**Ancram Solar PV, LLC
Ancram Solar Planning Board Application
Walden Environmental Engineering
Comments
3333 State Route 82
Ancramdale, NY 12503**

**SEPTEMBER 2025
REVISED September 22, 2025**

Ancram Solar Planning Board Application Comments**1.0 ABSTRACT**

Figure 1: *Reflectance profiles of typical PV module materials.*

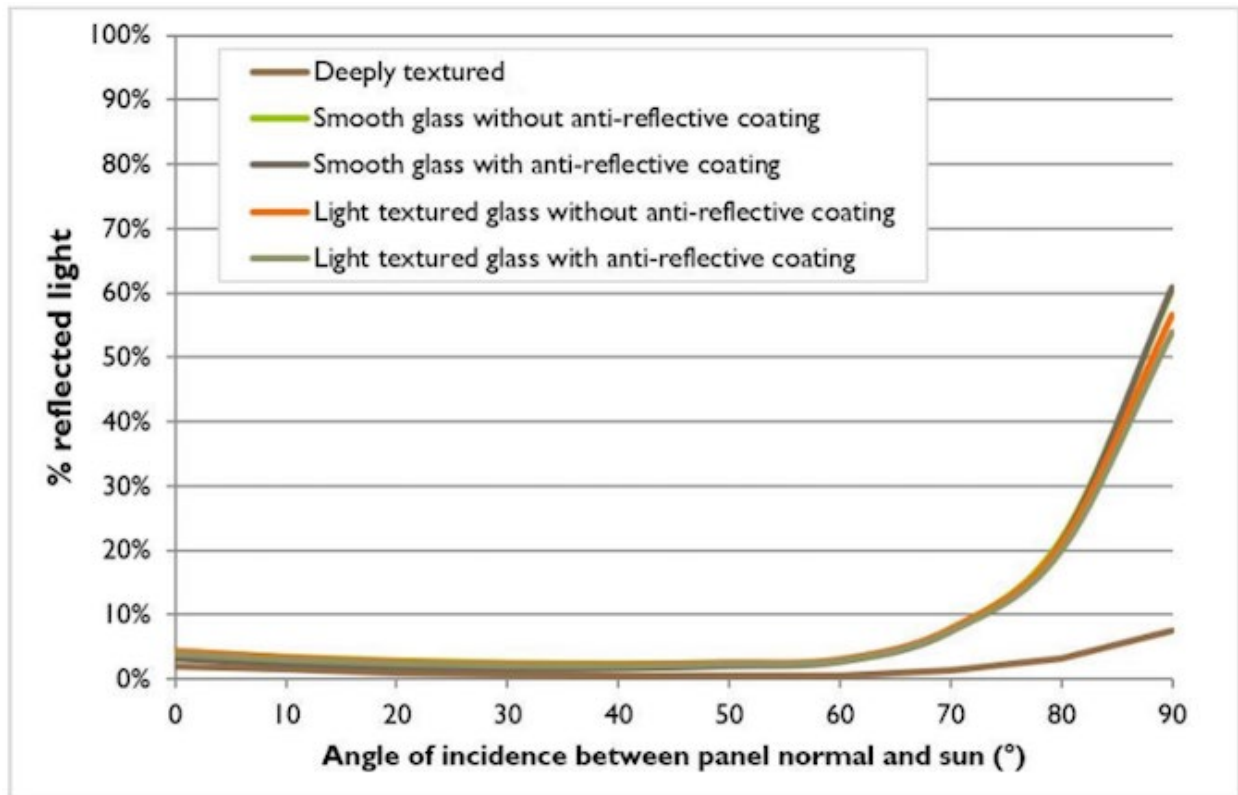
Of course, as stated in the website <https://www.pagerpower.com/news/common-misconceptions-surrounding-glitter-and-glare/>, “the key issue is specular reflections when it comes to glare. Whilst many solar panels have anti-reflective coatings that will reduce the intensity of any specular reflection, it is shown in Figure 1 [1] below that the majority of coatings only make marginal differences of the percentage of sunlight reflected. This is because most solar panels have a shiny surface or glass panel to protect it, whilst still letting light through. Shiny surfaces, such as glass, are capable of producing specular solar reflections and this is the main cause of glint and glare effects.

The graph also shows how the percentage of reflected light changes with the angle of incidence from the four common solar panel surface types. The graph shows a rather surprising result, in that the percentage of reflected light changes marginally depending on the surface type modelled. Only solar panels that are ‘deeply textured’ reflect relatively low levels of incoming light across all angles of incidence. It is understood however that solar panels with a deeply textured surface are often not viable for an actual PV development due to cost and the current availability of the technology. At most, manufacturers typically claim to produce solar panels with an ‘anti-reflective coating’. Only in borderline circumstances may the percentage of reflected light be reduced through the implementation of ‘rougher’ panel surfaces such that the intensity of reflectance reaches acceptable levels. i.e. trying to eliminate ‘yellow’ glare towards aviation receptors. “
